**TECHNICAL DRAINAGE STUDY
UPDATE #4 ADDENDUM
Skye Canyon Phase 2 Infrastructure**
City of Las Vegas, Nevada

Job No.: OLY1501.000
Date: July 2017

Subject: Addendum to the Technical Drainage Study Update #4 for Skye Canyon Phase 2 Infrastructure (CLV # DS4739G)

NINETY-FIVE MANAGEMENT, LLC.
SKYE CANYON - PHASE 2 INFRASTRUCTURE
PARCEL & DISCHARGE STUB MAP

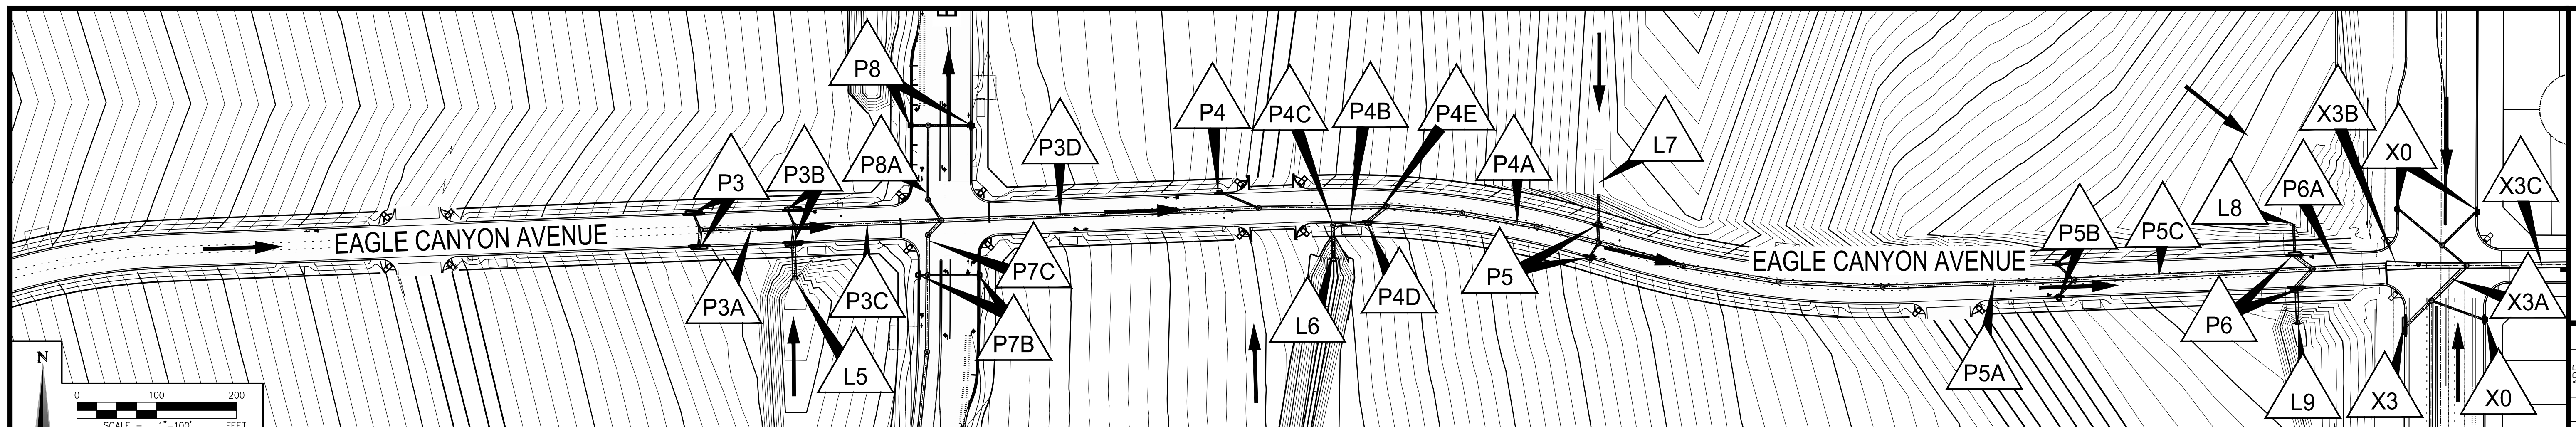
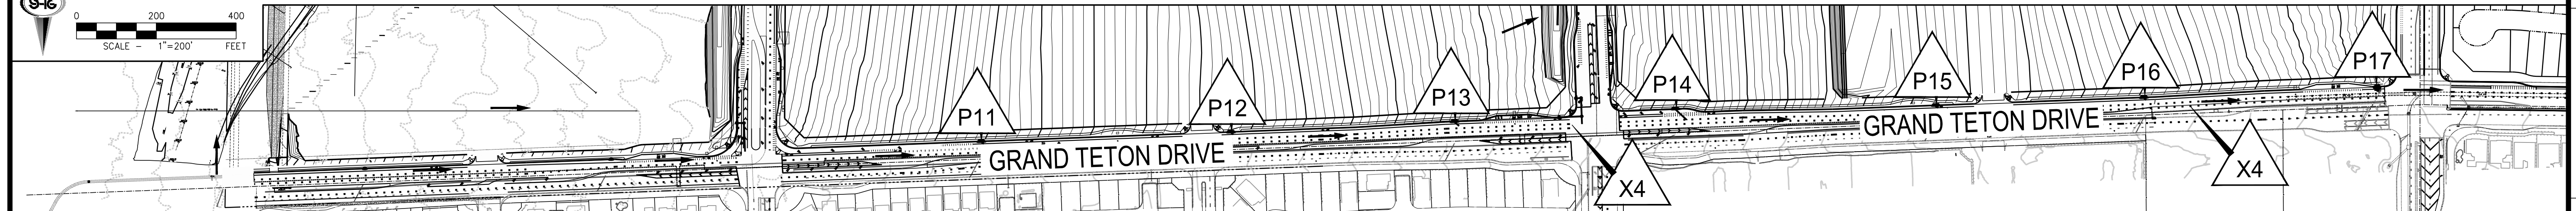
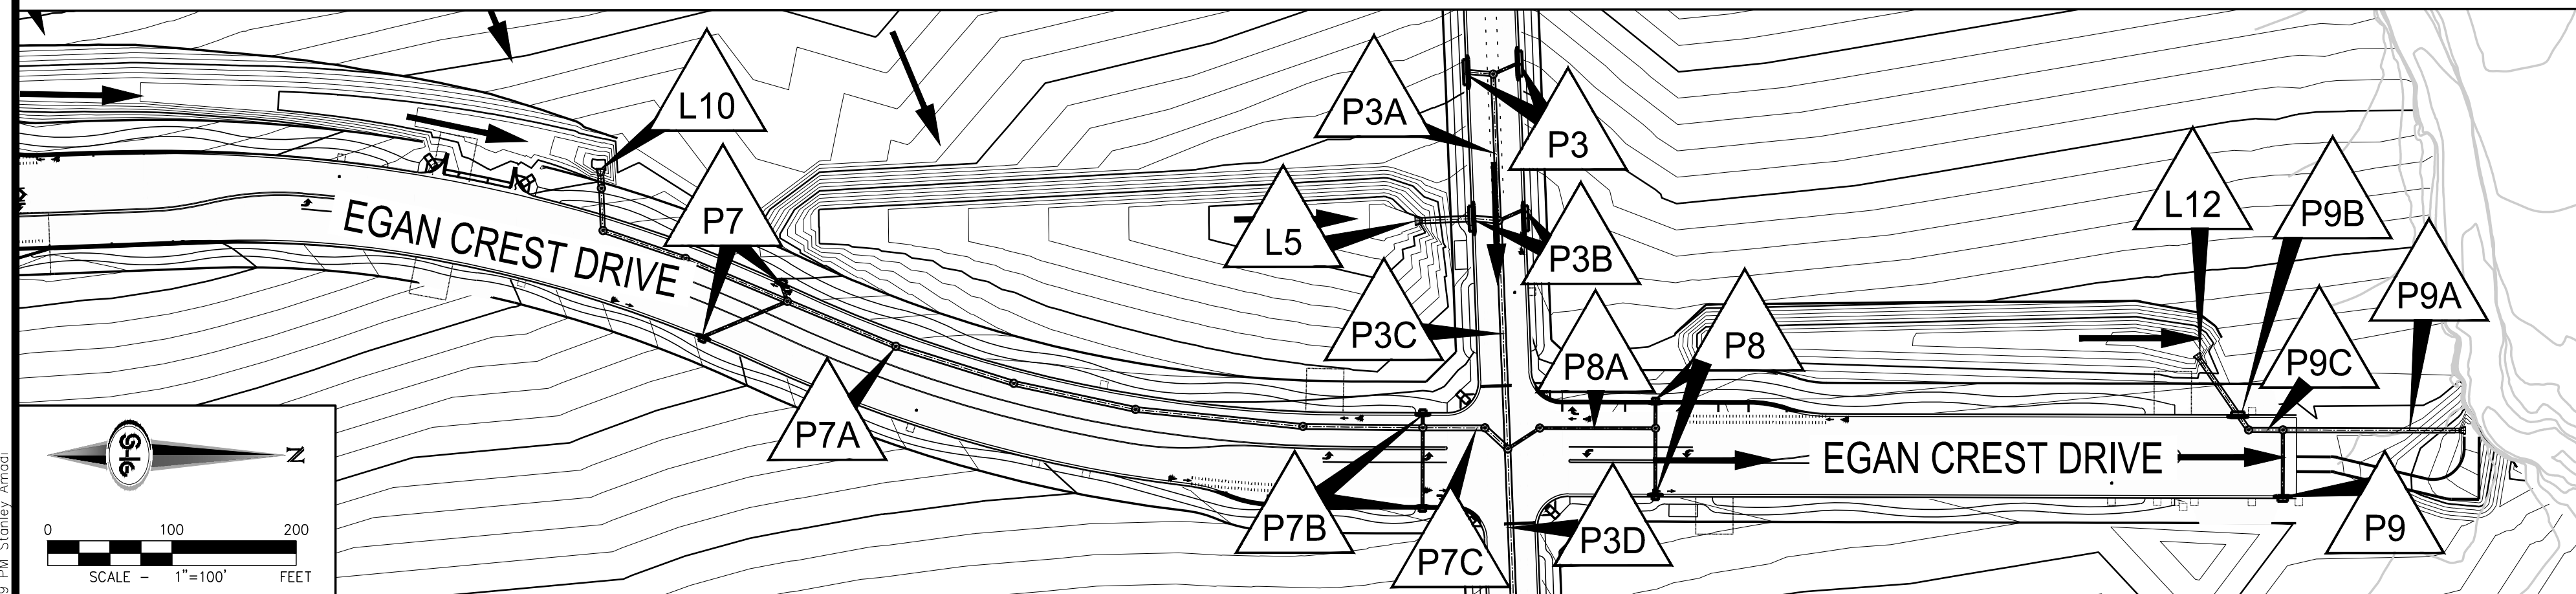
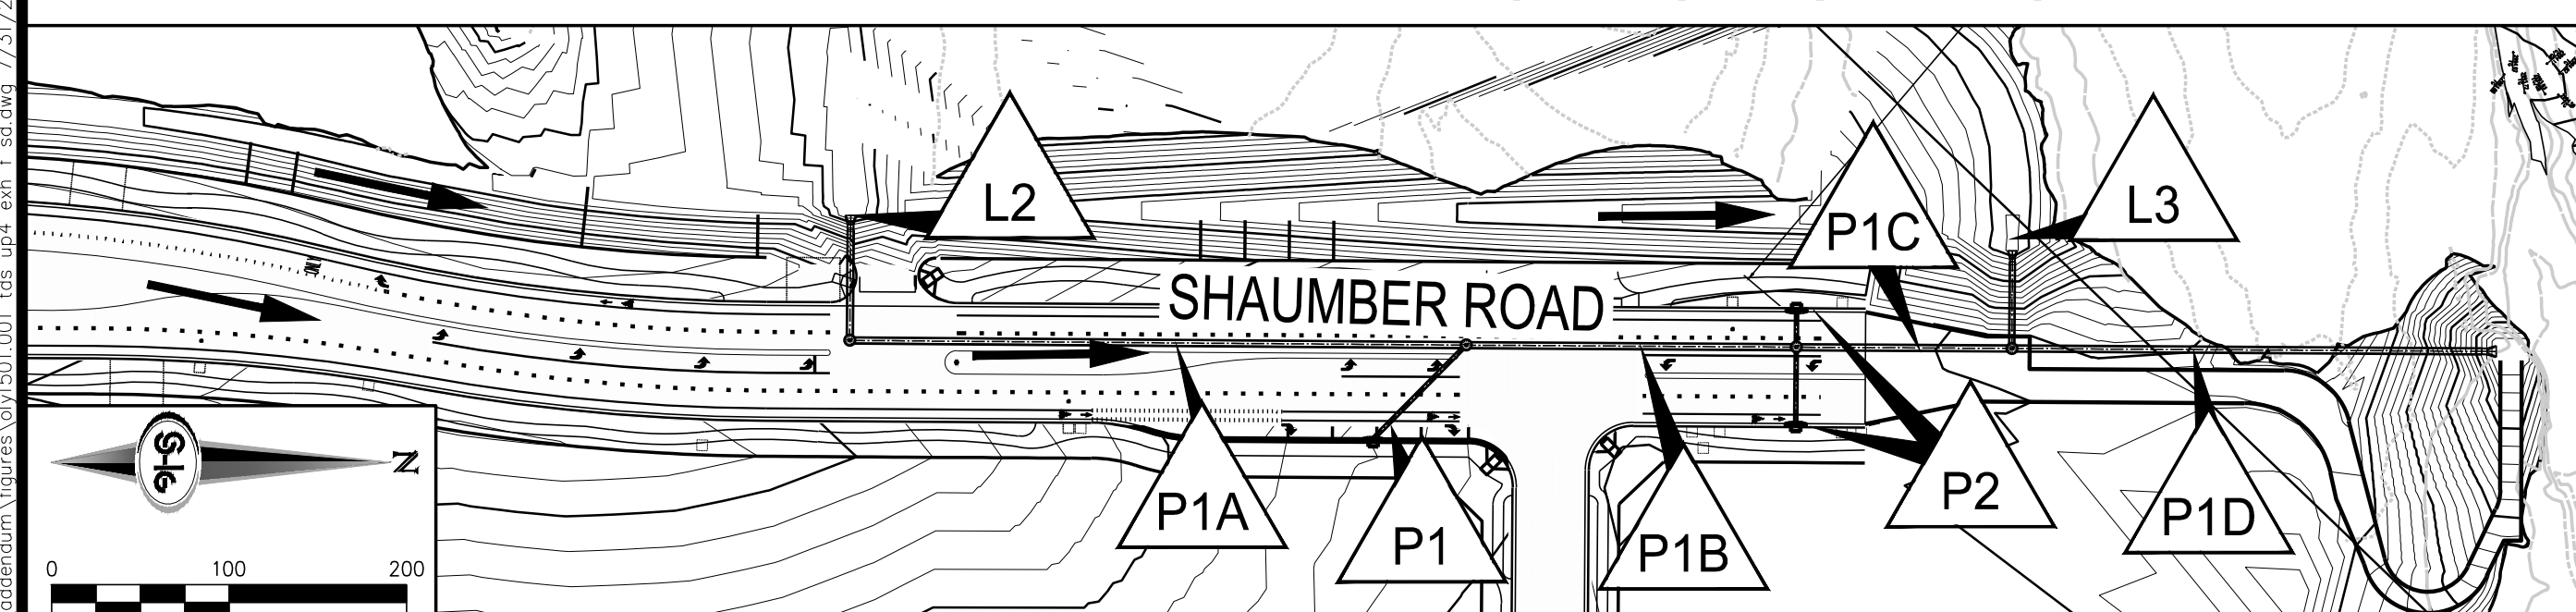
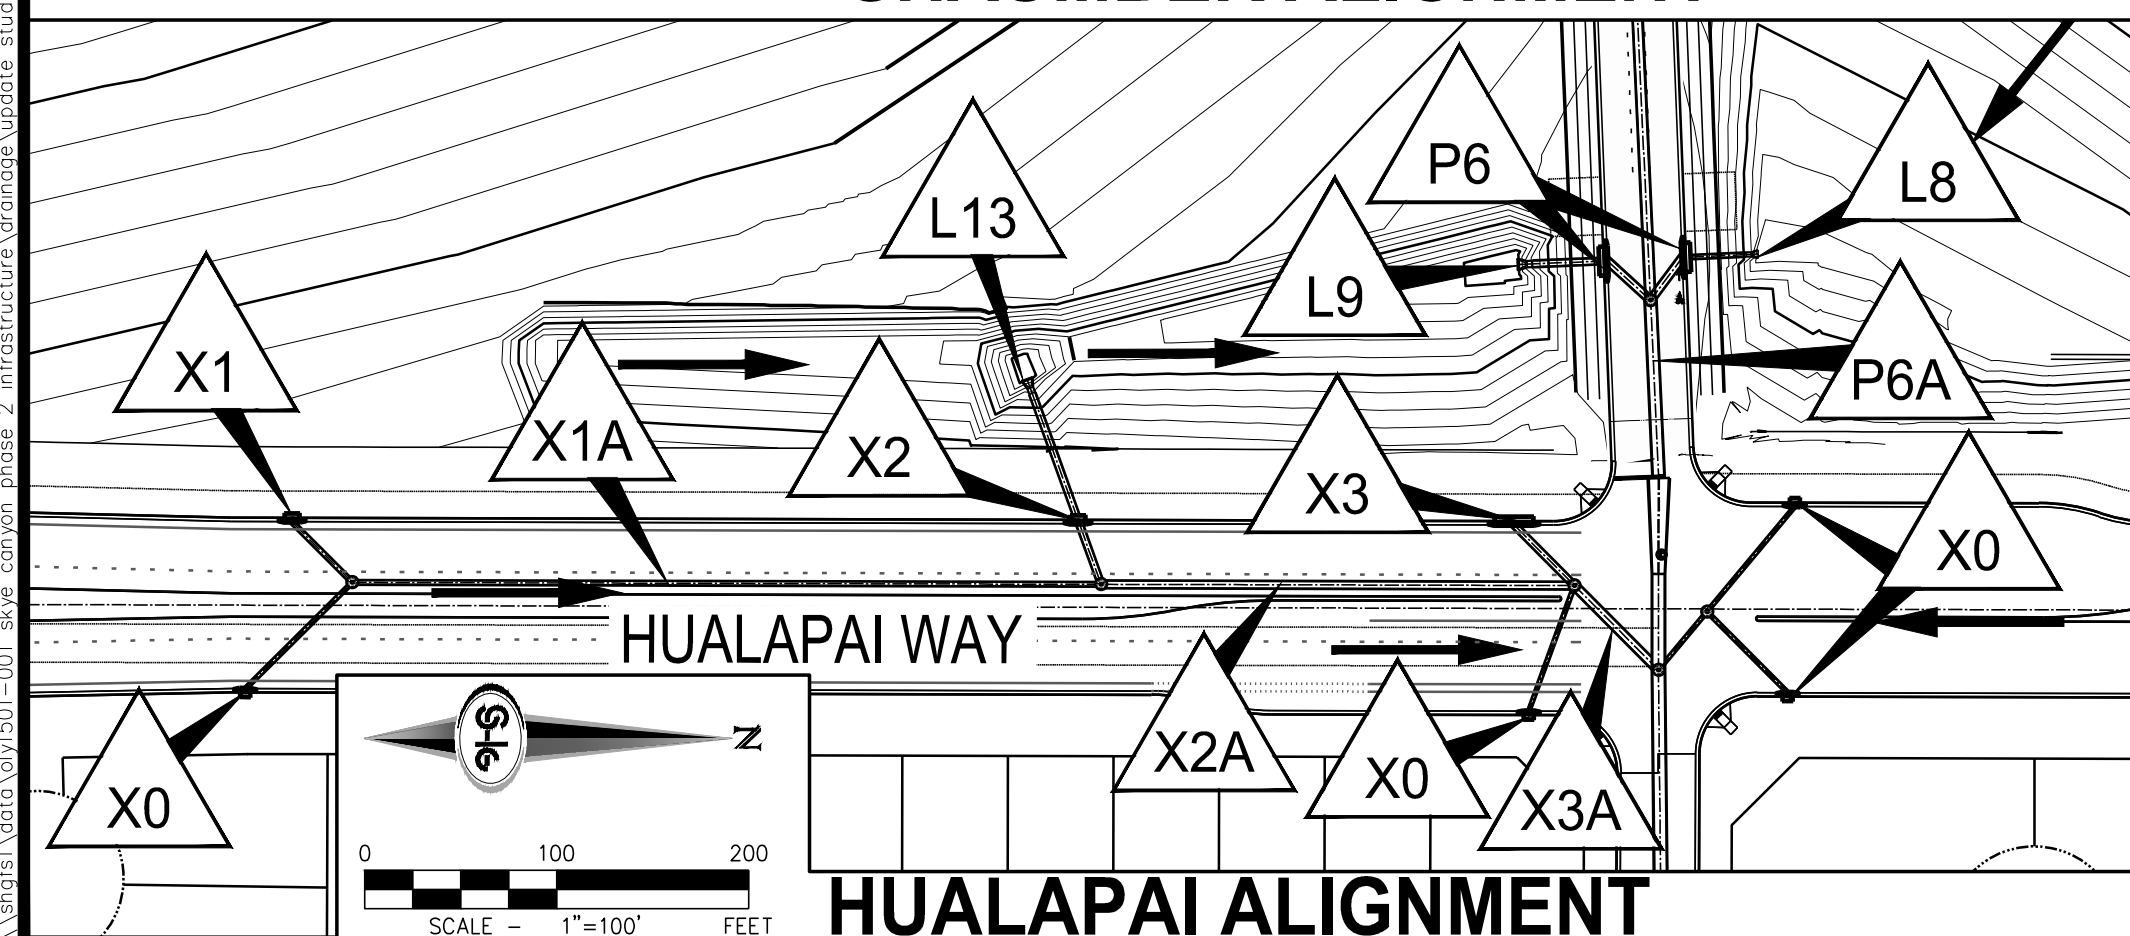
1. **Comment:** *Provide an exhibit or index map which clearly identifies all the Phase 2 Parcels (2.xx) and the discharge stubs in each parcel.*

Response: Noted. Please refer to Exhibit G in Appendix B identifying the Phase 2 parcels and their respective discharge stubs.

*Trial run for connection to approved stub location
@ Eagle Canyon Avenue Sta: ECA 54+59.97*

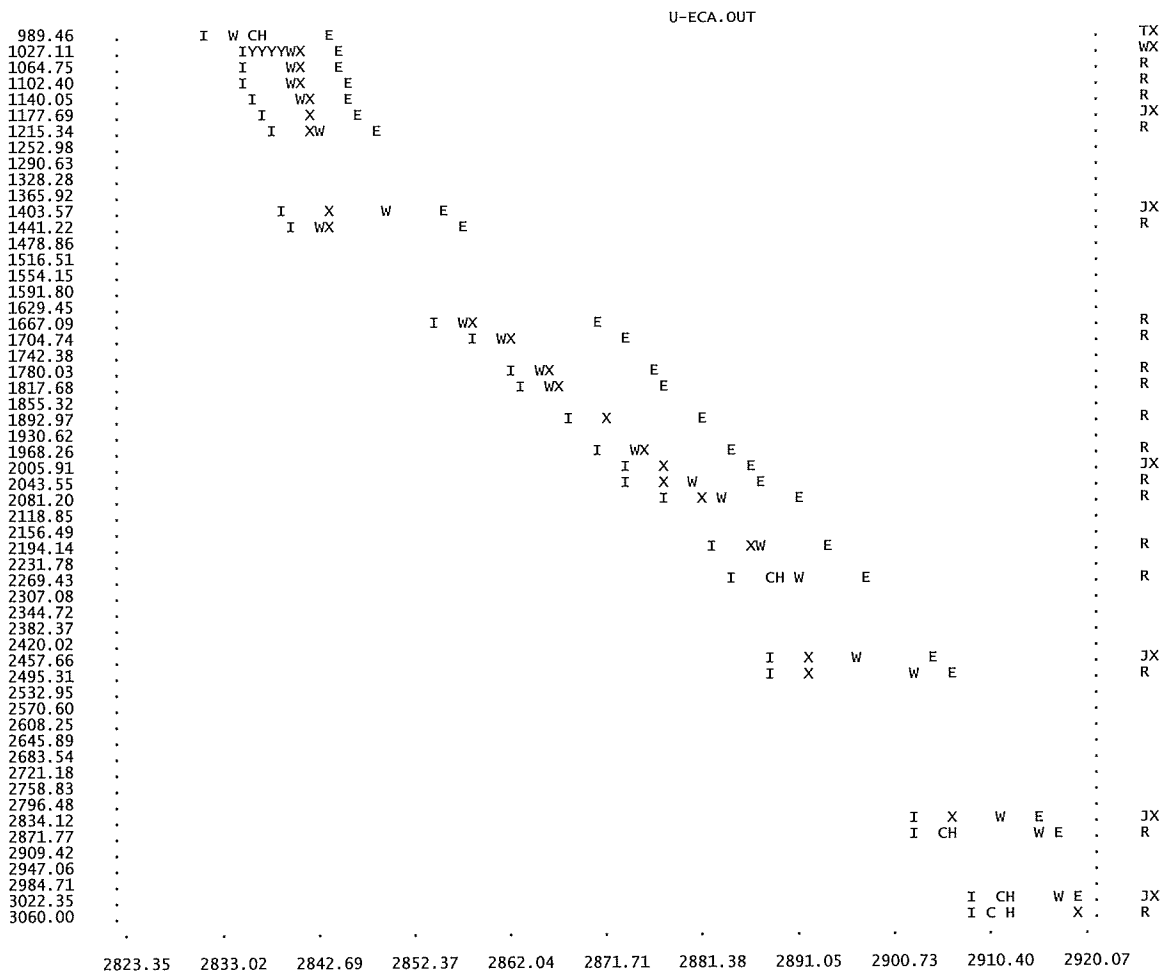
- *The "Matchline" between the two sheets is shadowing the relocated 36"-stub. Shift the "Matchline" for a better and clear view of the proposed relocated stub.*
- *The proposed connection of the relocated stub through two inlets, especially a lateral between two inlets will cause undue maintenance problems.*

Provide a storm drain manhole at the mainline in Eagle Canyon Avenue for the connection of the relocated 36"-stub.

Two sets of trial hydraulic models for the mainline (Eagle Canyon Avenue SD) and lateral (Parcel 2.27 SD) have been provided to demonstrate that a connection at any location upstream of SDMH #25 will result in backflow surcharge into Parcel 2.27. One set of models is for a connection to SDMH #24 at previously proposed stub location and the other is with a new manhole located at approximate Eagle Canyon Avenue station ECA 55+90.18. Both sets of models show that the flows will surcharge at the low point within Parcel 2.27 due to the significantly high HGLs in the Eagle Canyon Avenue mainline. Please refer to Appendix C for the trial mainline and lateral WSPGW models U-ECA.WSP and P4-L1.WSP respectively.
